Certificate of Appropriateness
BAR # 24-08-02
7 Gildersleeve Wood; TMP 110017100
Oakhurst Circle-Gildersleeve ADC District
Owners/Applicants: Mary and Scott Prior
Project: Construction of entry portico

City of Charlottesville
Board of Architectural Review
Staff Report
August 20, 2024

Project: Construction of entry portico

West elevation: Proposed portico - conceptual

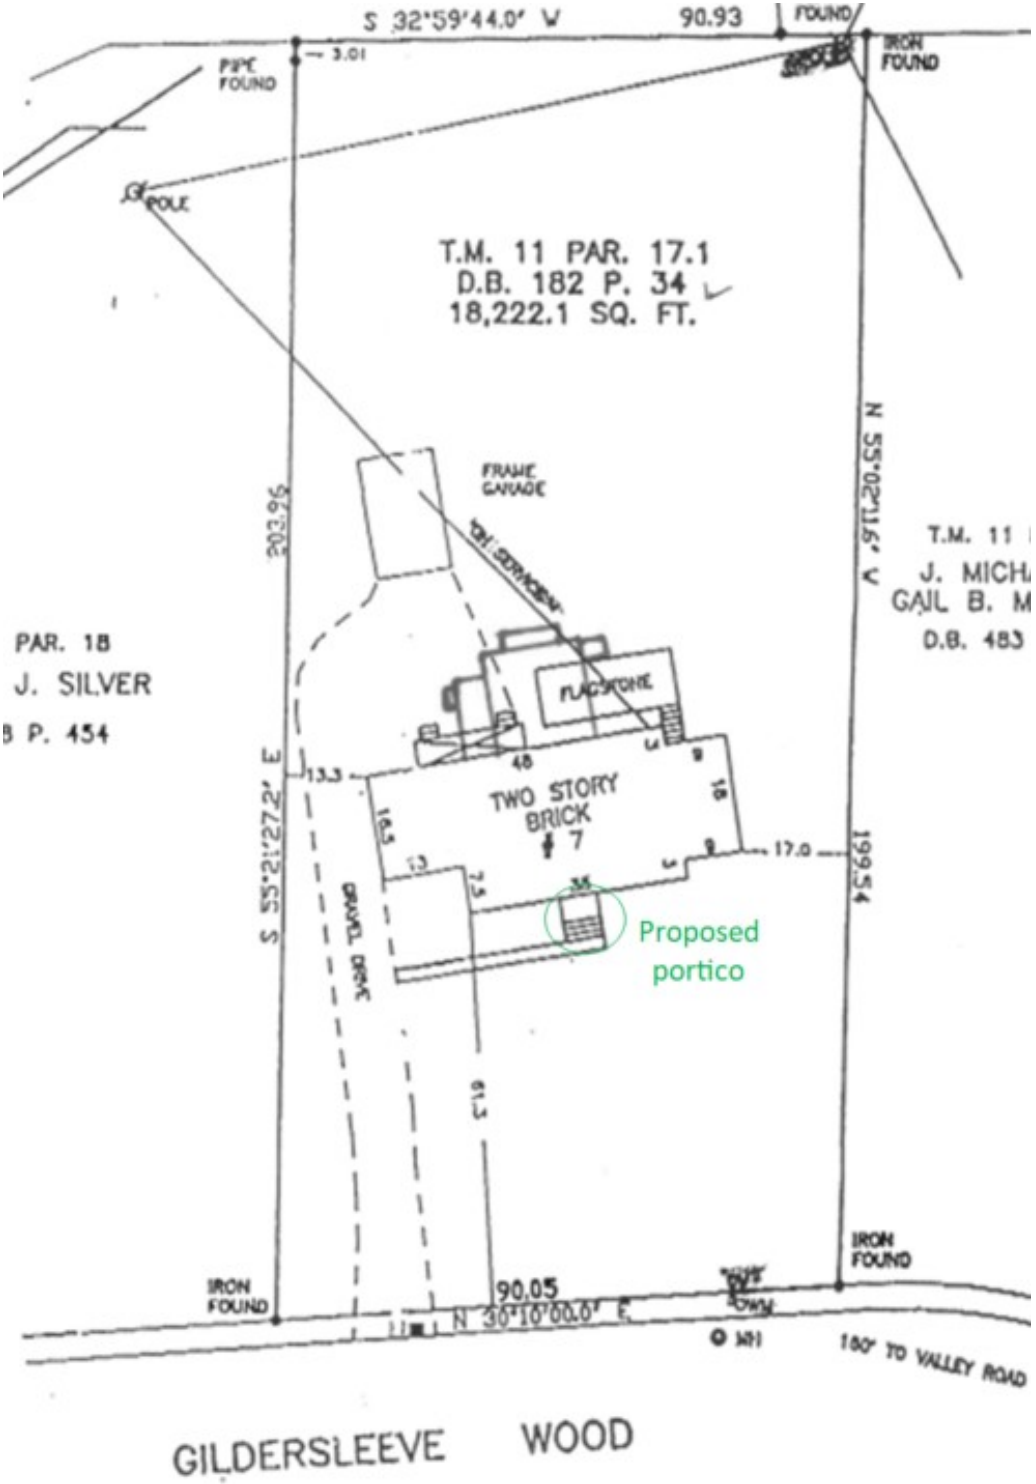
Staff recommends approval of the requested CoA. While the proposed portico is an alteration that will replace original elements, it is architecturally appropriate for this Colonial Revival dwelling, such that it will not redefine or compromise the historic character of the structure or the district. [In the Appendix are photos of two-story brick, Colonial Revival houses with a portico entrance.]

Constructing the portico will require removing the existing pilasters and arched-pediment. While likely original to the house, these elements are not unique, an infrequent or the first or last remaining example within the City (see Appendix), and they are not the work of a noted architect or master craftsman. The house is not associated with an important event or individual. In brief, while a contributing resource to this historic district, it is likely not eligible for individual listing.

Because the portico design is appropriate for a Colonial Revival house, replacing the original elements will not impair the essential form and integrity of this historic property or the district. Additionally, construction this portico will not prevent or preclude later reproduction and installation of the original elements. [The applicant has documented the entrance with detailed photographs, which will become memorialized in the BAR archive.]

**Metal railing to
be omitted.**

Existing brick stoop to remain.

Standing-seam metal roof to match house.
